## **Safety Evaluation Report**

**Safety Basis for Certification of Project Maximus LEU Type A Drums as a  
Type AF Packaging Configuration, ORNL/NTRC-020, Vol. 1 to 2, Rev. 1,  
February 2007**

**Docket No. 06-48-9865**

**July 9, 2007**

Figure 1. U-235 mass versus H/U-235 ratio for a homogeneous mixture of  $\text{UO}_2$  and water in a spherical configuration with 30 cm of water reflection that has  $k_{\text{eff}} + 2\sigma < 0.9271$  (USL sphere)

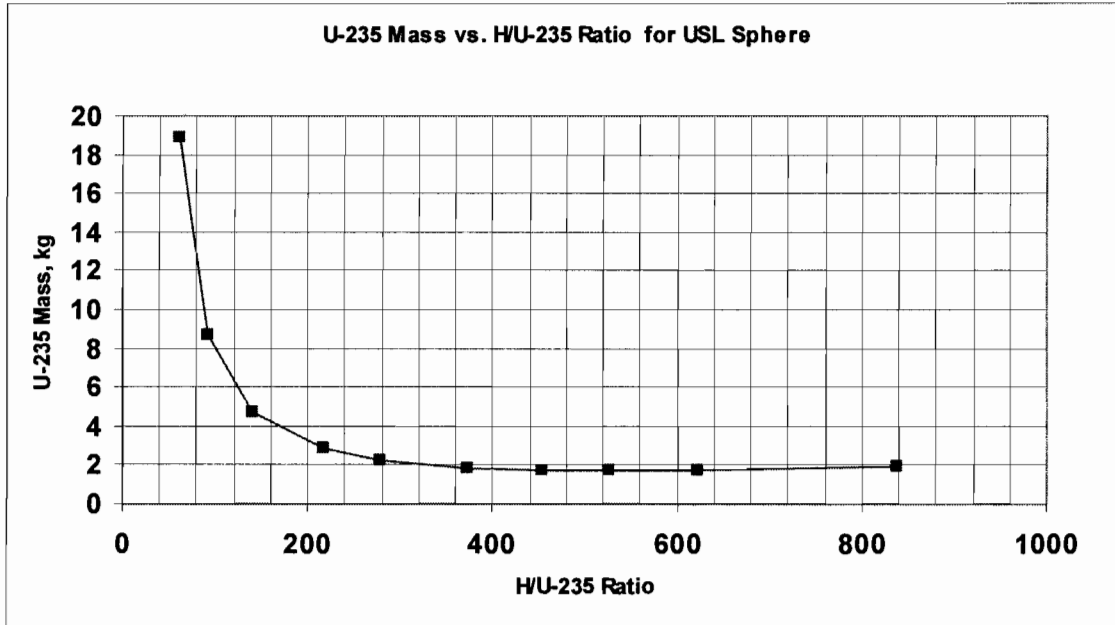
The USL value of 0.9271 is used as a conservative criterion for the determination of the spherical safe mass limits shown in Table 7 of ORNL/NTRC-20, Rev. 1. Altogether thirteen cases were calculated with the volume fraction of water in the  $\text{UO}_2$ -water mixture varying between 15 and 90%. (The corresponding ratio of H:  $^{235}\text{U}$  varied between 16.4 and 836.9, respectively.) Figure 1 below is a plot of the results of Table 7 showing that the mass of  $^{235}\text{U}$  in a USL sphere drops off significantly with increasing volume fraction of water, reaching a minimum at H:  $^{235}\text{U} = 526.9$  (or 85% volume fraction of water in the  $\text{UO}_2$ -water mixture). The lowest value of  $^{235}\text{U}$  mass obtained in the USL sphere calculations is 1.685 kg, which bounds the total  $^{235}\text{U}$  mass of 1.385 kg in two LEU oxide packages that contain the largest amount of  $^{235}\text{U}$ . (i.e., Overpack drum no. P0010 and P0039 in Table 4, ORNL/NTRC-20, Rev. 1)

The EM-60 staff performed an independent KENO calculation to confirm the results in Table 7. For the case of 85% volume fraction of water in the  $\text{UO}_2$ -water mixture, the calculated  $k_{\text{eff}}$  is 0.92512 ( $\pm 0.00043$ ), versus 0.92504 ( $\pm 0.00045$ ) found in the output file of Case sp\_85 in ORNL/NTRC-20, Rev. 1. Both sets of results give values of  $k_{\text{eff}} \pm 2\sigma$  below the USL limit of 0.9271.

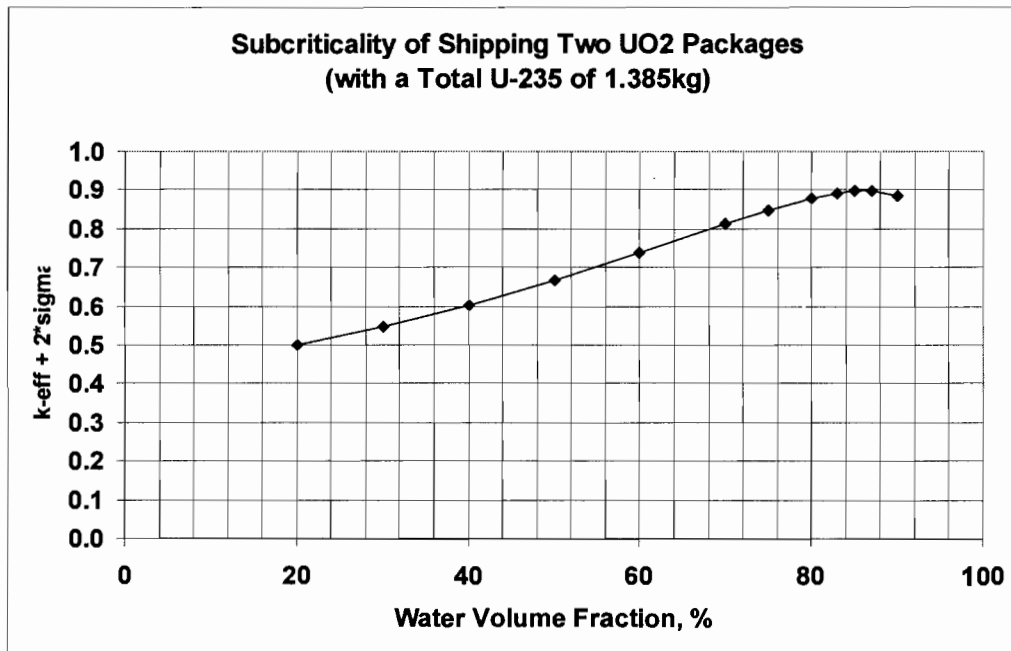
The EM-60 staff also performed additional KENO calculations to confirm independently that any two of the 75 LEU oxide packages will remain subcritical under HAC. The calculations assumed a total amount of  $\text{UO}_2$  (with 1.385 kg  $^{235}\text{U}$ ) leaking from two LEU oxide packages and mixing homogeneously with water in a spherical configuration, with varying water moderation and full (30 cm thick) water reflection. The most reactive configuration occurs near the water volume fraction of 87% (Fig. 2) with a calculated maximum  $k_{\text{eff}} + 2\sigma$  of 0.89703, which is well below the USL of 0.9271.
